TWINGO

This note is in addition to Technical Note n° 346A

ADAPTING THE FLOOR PANEL TO FIT A CONSOLE SUPPORT BRACKET**(For vehicles manufactured before 03/06/1996)***Other sub-section concerned :*

Console support bracket

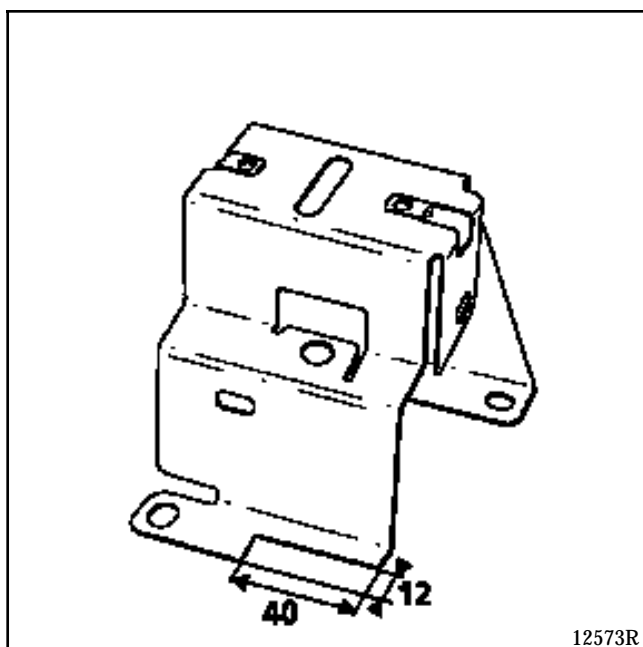
The console support bracket for the vehicle is to be modified and re-used.

To fit this a bolt needs to be crimped onto the floor panel. This bolt will also be used to secure the computer and the heat shield under the floor panel.

MODIFYING THE CONSOLE SUPPORT

Cut the section to the dimensions shown below.

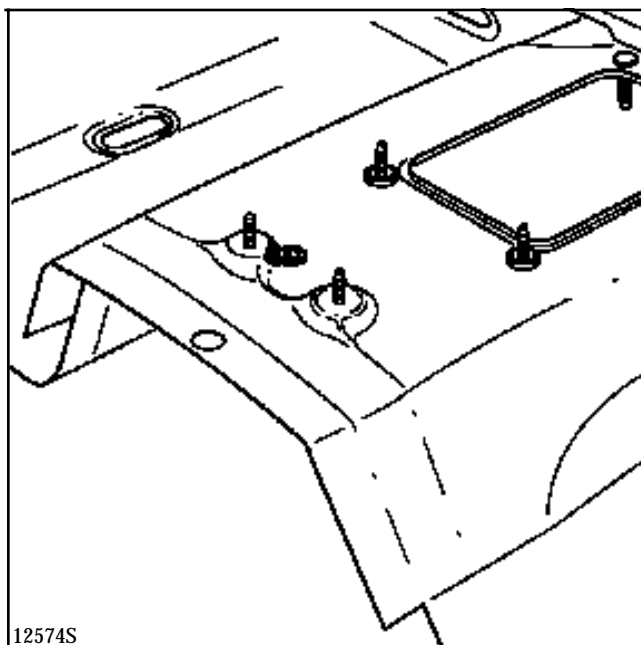
Shape the boss using a punch so that the shoulder of the bolt crimps the plate onto the floor panel.

Fit the console support and drill **9.5 mm** through the two panel thicknesses (floor panel tunnel stiffener).

Console support bracket

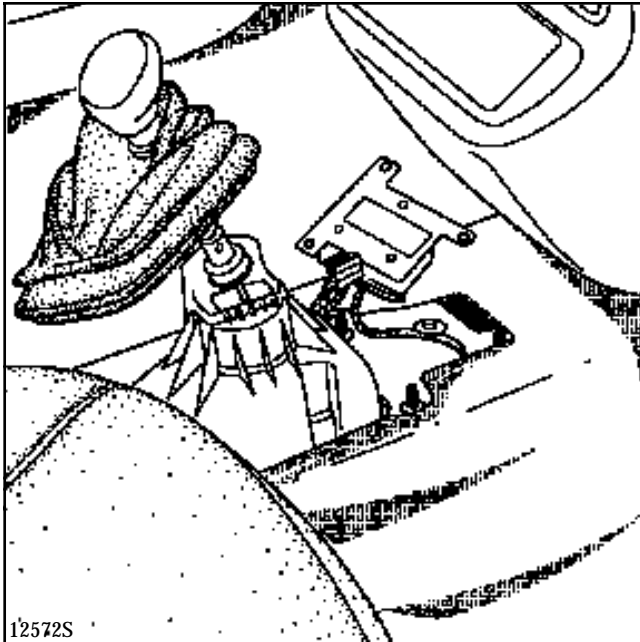
Cut the central floor panel carpet as shown below.
